DATE	REVISION
STATE OF HAWAII DEPARTMENT OF TRANSPORTATION HIGHWAYS DIVISION INDEX TO DRAWINGS, ABBREVIATIONS, SUMMARY OF ESTIMATED QUANTITIES HAWAII BELT ROAD KUPAPAPULUA BRIDGE WIDENING HAMAKUA DISTRICT Federal Aid Project No. BR-019-2(38) Scale: As Noted Date: June 23, 2003

SHEET No. S-1 OF 36 SHEETS

CONSTRUCTION SEQUENCE

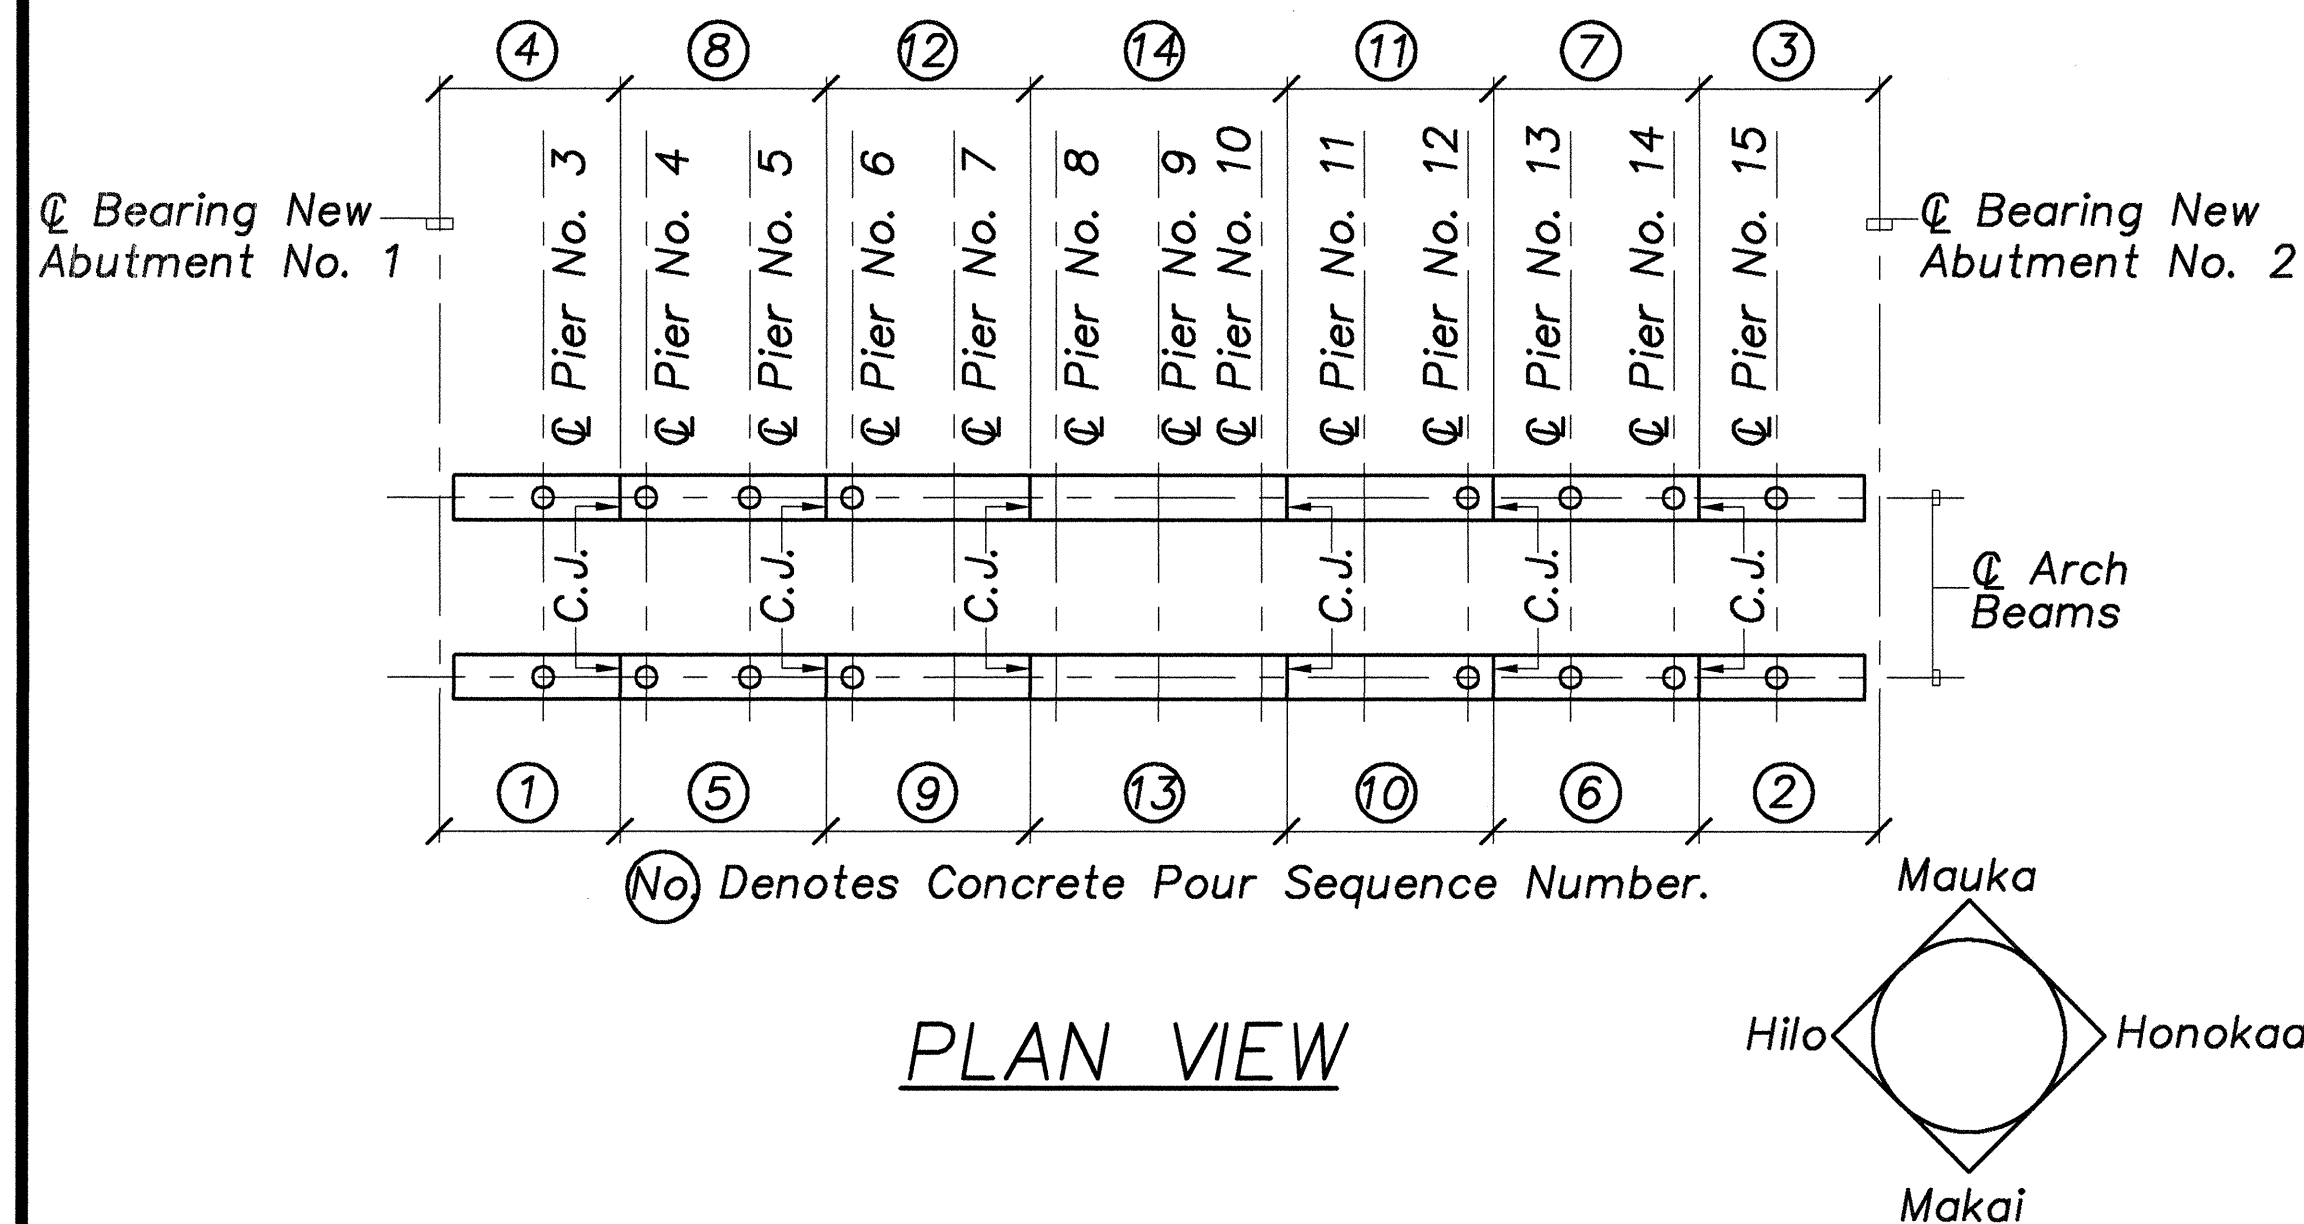
4/15/02	REVISED BRIDGE WIDENING DIMENSION ON "PLAN VIEW" AT STAGES 10 AND 12.
DATE	REVISION
STATE OF HAWAII DEPARTMENT OF TRANSPORTATION HIGHWAYS DIVISION CONSTRUCTION SEQUENCE	
HAWAII BELT ROAD KUPAPAPUA BRIDGE WIDENING HAMAKUA DISTRICT Federal Aid Project No. BR-019-2(38)	
SCALE: AS NOTED	DATE: AUG., 2001
SHEET No. S-3 OF 30 SHEETS

WEEPHOLE DETAIL

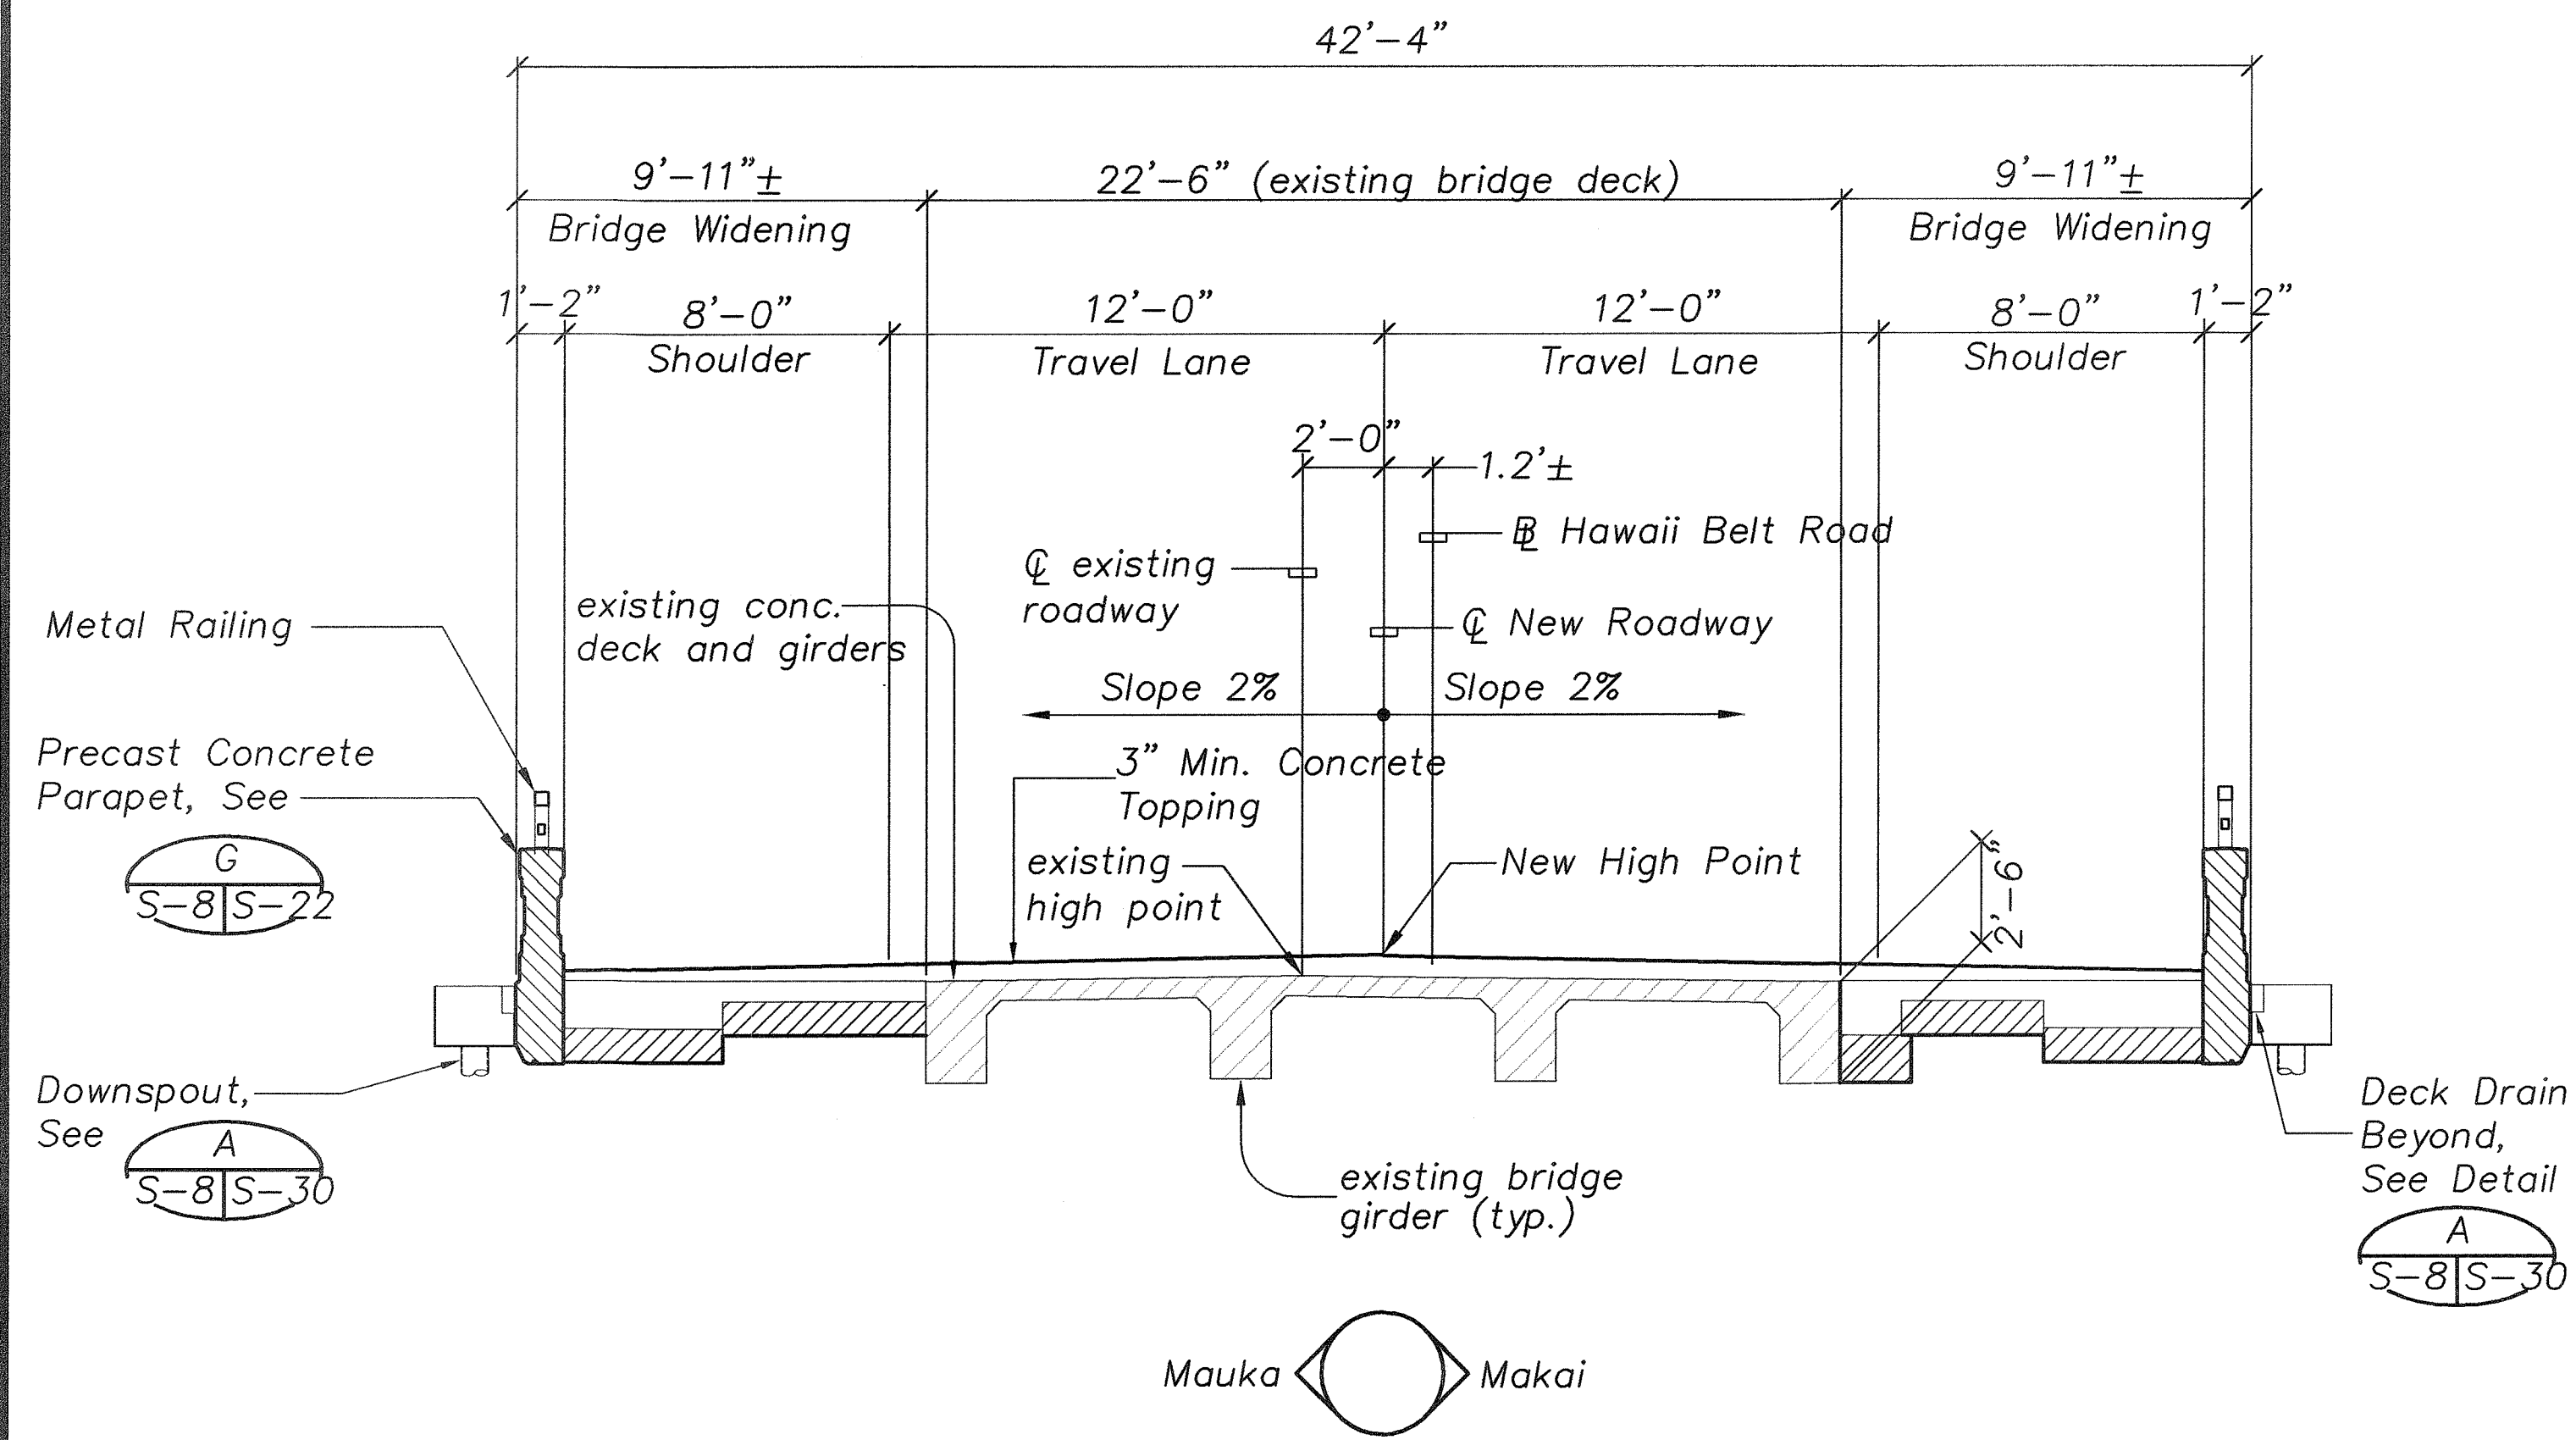
- Provide 4" Diameter PVC Pipe Drains at 8'-0" o.c.. Maximum 2" above Top of Abutment Footings in Abutment Walls. Adjust Reinforcing Bars, as Required, To Clear Drains.
- 6" Square ~~Galvanized Steel Wire 1/4" Mesh Hardware Cloth~~ (Minimum Wire Diameter 0.025"). Anchor Firmly To ~~Back face~~ both face of ~~Wing Wall~~.

REVISE #7 TIES ARRANGEMENT IN ARCH BEAM AT PIERS
Scale: As Noted

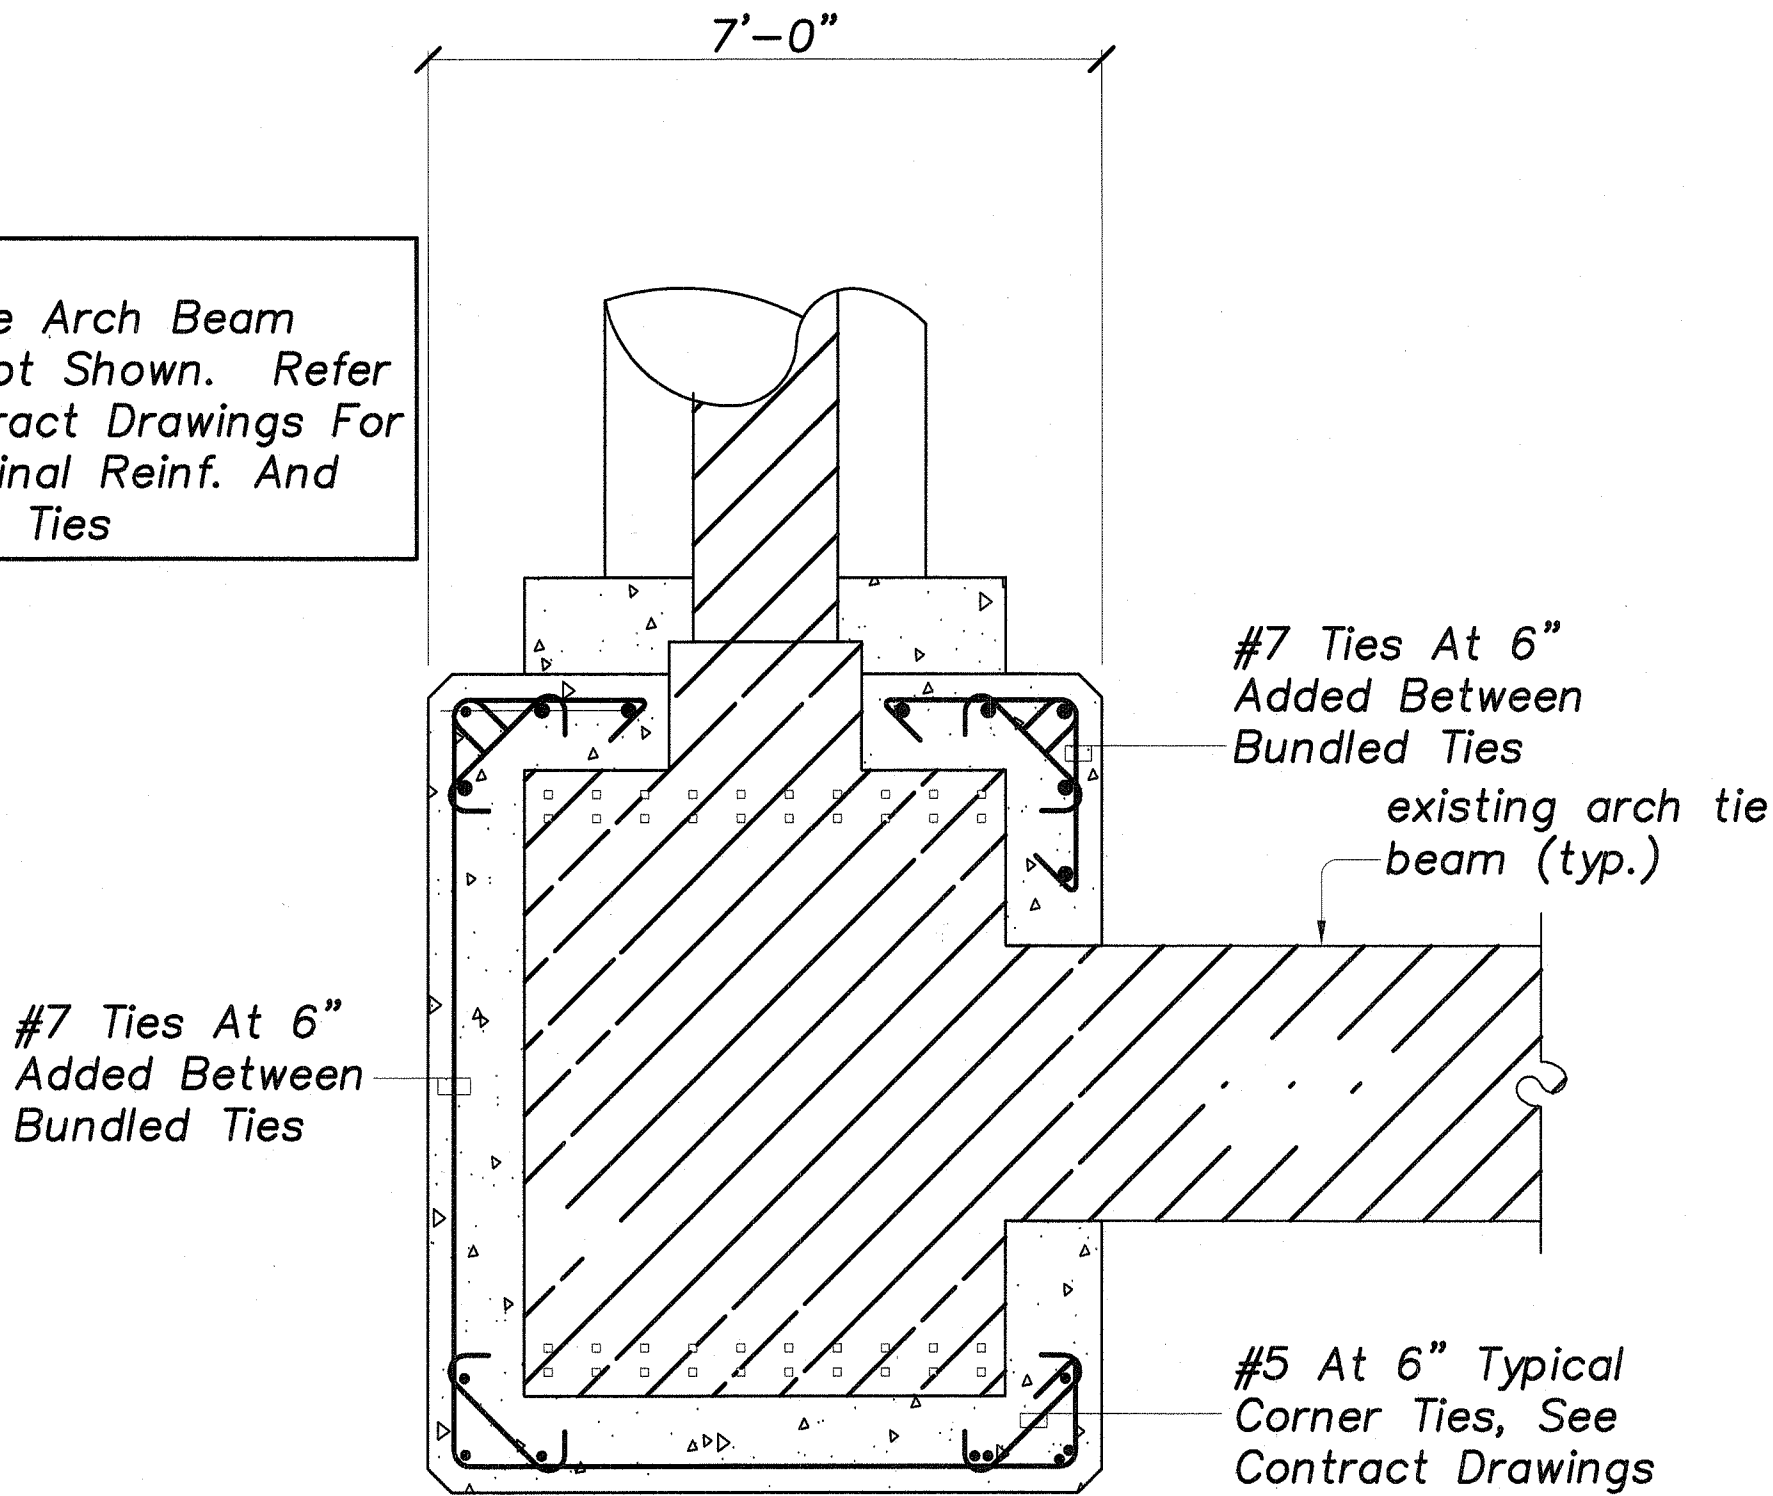
NOTE: For revised #7 ties arrangement at piers - see Det. A

Note:
Complete Arch Beam
Reinf. Not Shown. Refer
To Contract Drawings For
Longitudinal Reinf. And
#5 Hook Ties
